**GEOTECHNICAL AND GEOLOGIC HAZARD INVESTIGATION**  
**The Ridge Nests Development**  
**Powder Mountain Resort**  
**Weber and Cache Counties, Utah**

IGES Project No. 01628-008

July 15, 2016

Subject: Response to Review Comments  
Geotechnical Investigation  
The Ridge Nests Development  
Powder Mountain Resort  
Weber and Cache Counties, Utah

**FIGURE 1**

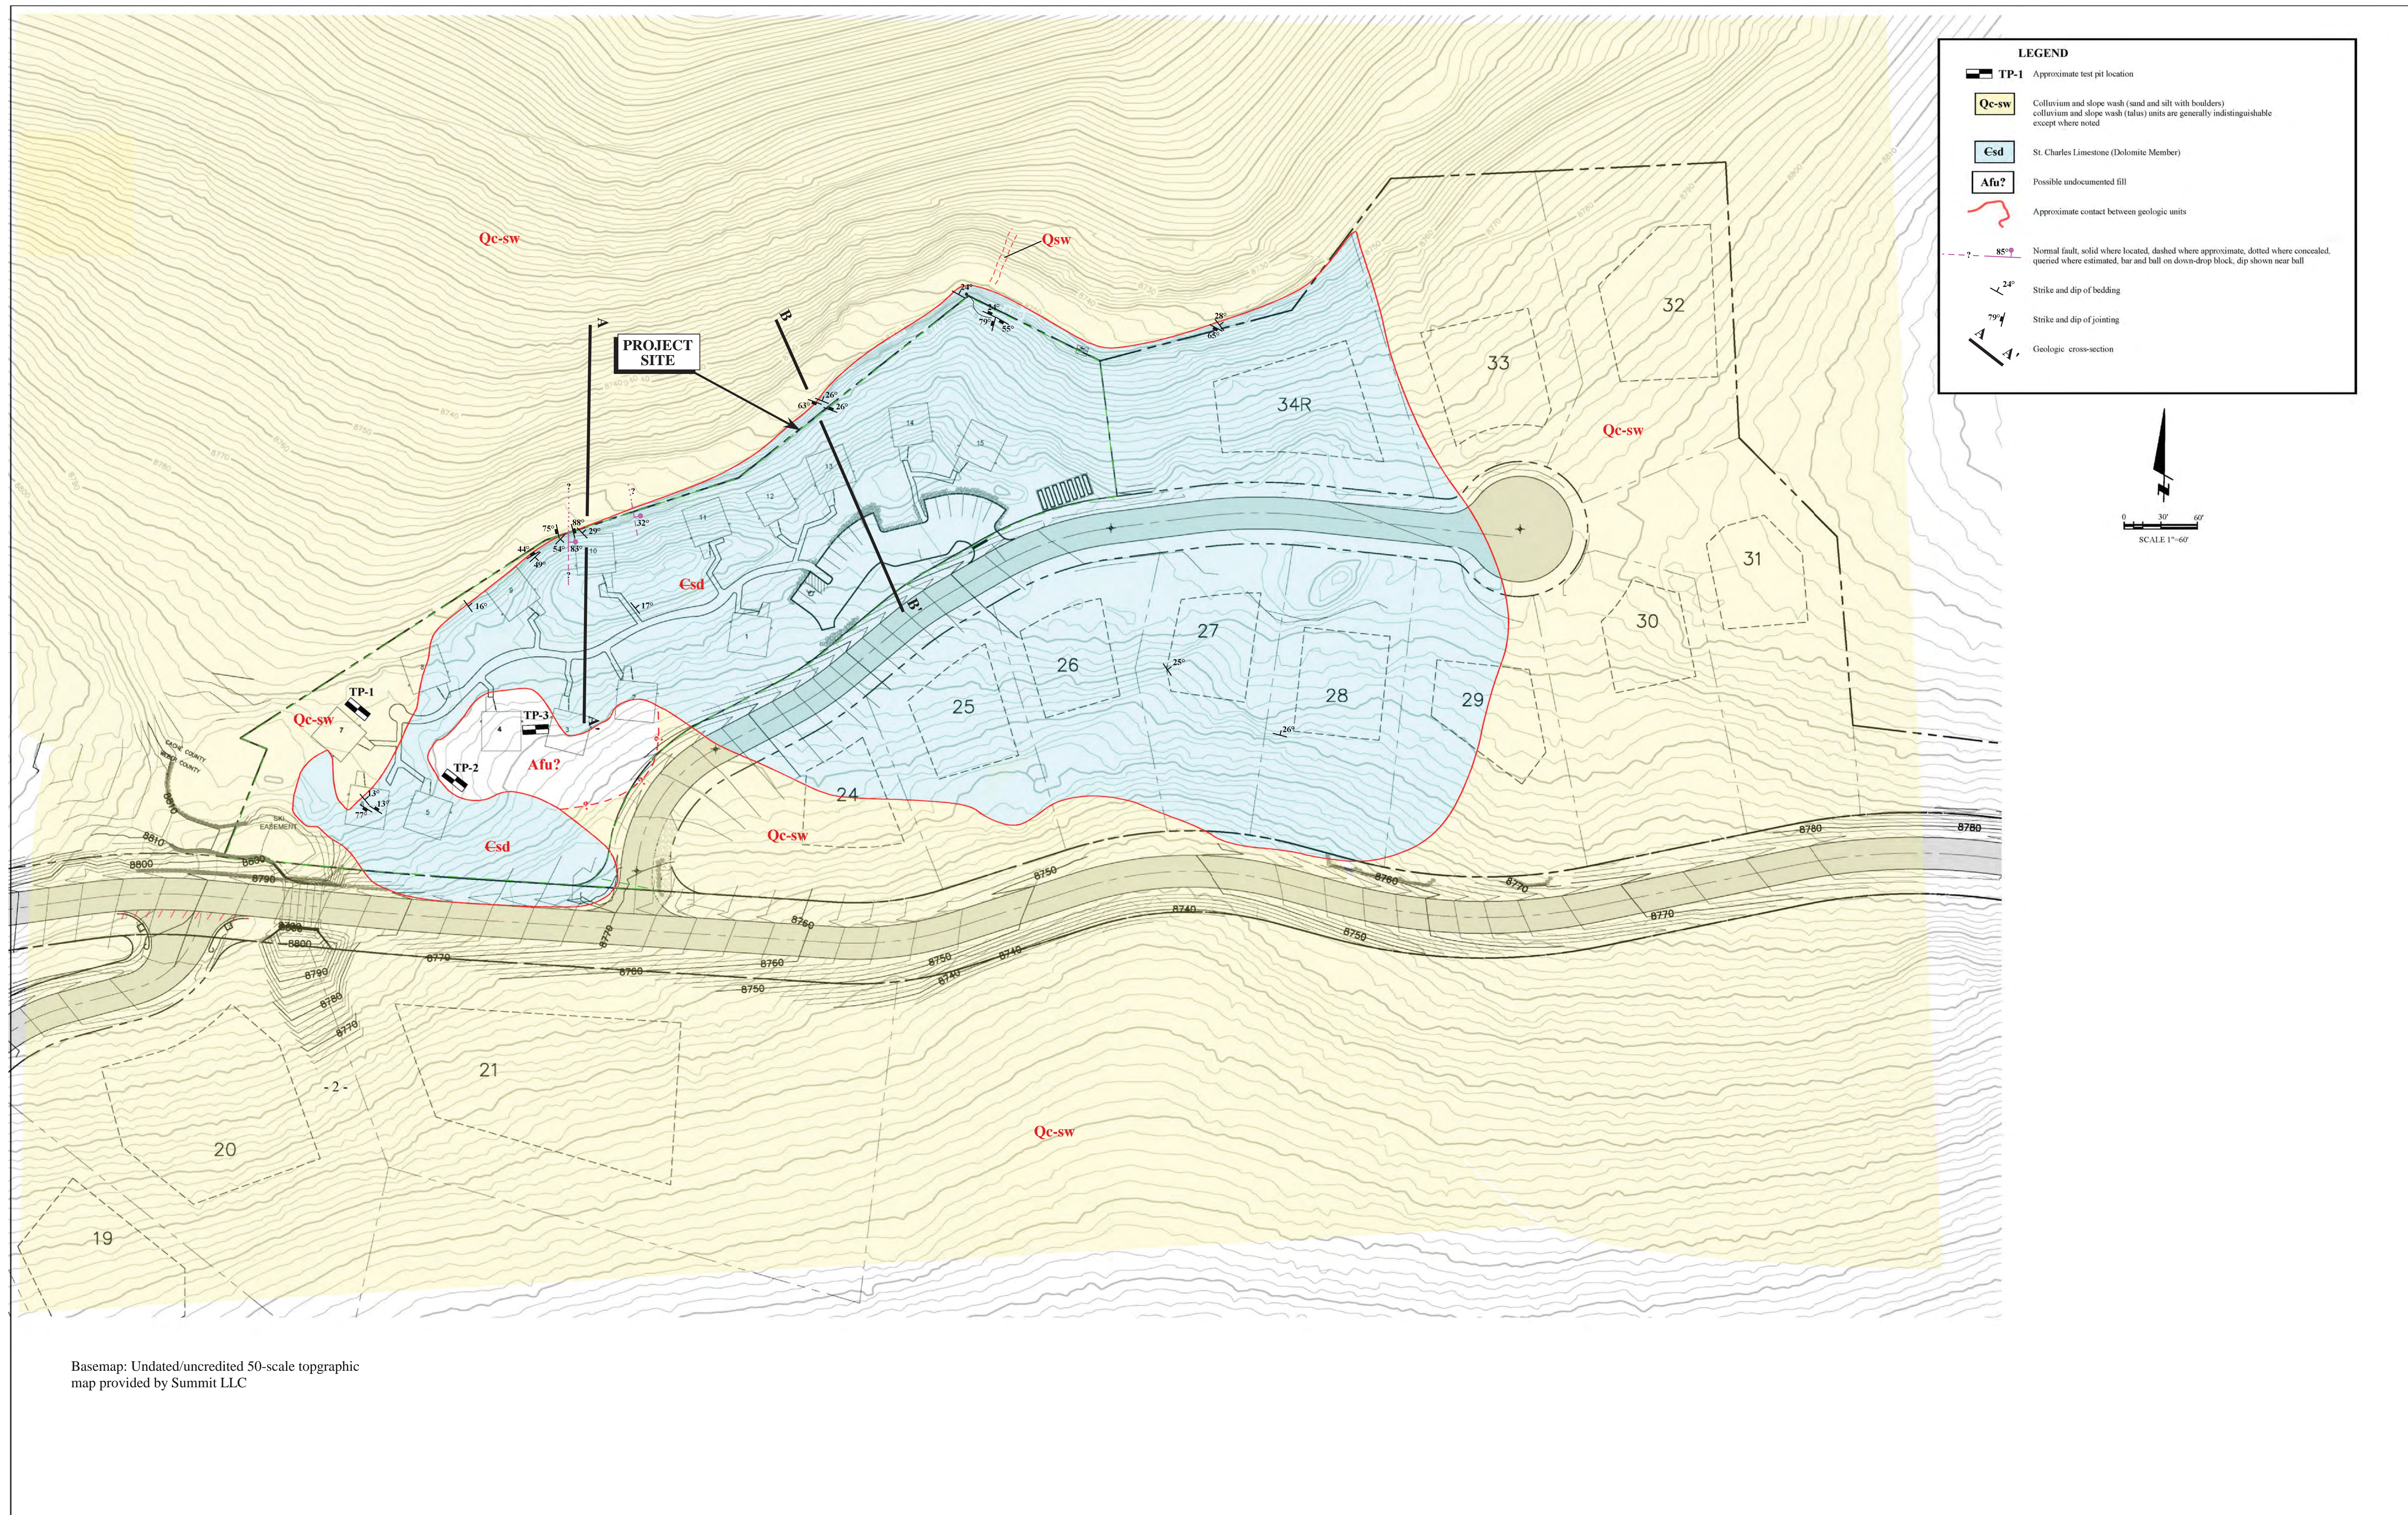
#### **Comment No. 1**

#### **Response to Comment No. 1**

The global stability of the slope was modeled using gSTABL7 slope stability software. Bishop’s Method and Janbu’s Simplified method was used to model the slope, as appropriate. For our analysis, we have assessed two representative sections, Section A-A’ and Section B-B’, illustrated on Plate 1 (*Geologic Map*) and the *Geologic Cross-Sections*, Figure 1, attached. Calculations for stability were developed by searching for the minimum factor-of-safety for both a circular-type failure and a block-type (translational) failure. For the circular analysis model, arcuate failure surfaces and homogenous earth materials were assumed. For the block analysis, anisotropic strength parameters in the bedrock was assumed, based on the apparent dip of bedding. A minimum static factor-of-safety of 1.5 and seismic factor-of-safety of 1.0 (global stability) was considered acceptable for this project considering the available information and design assumptions.
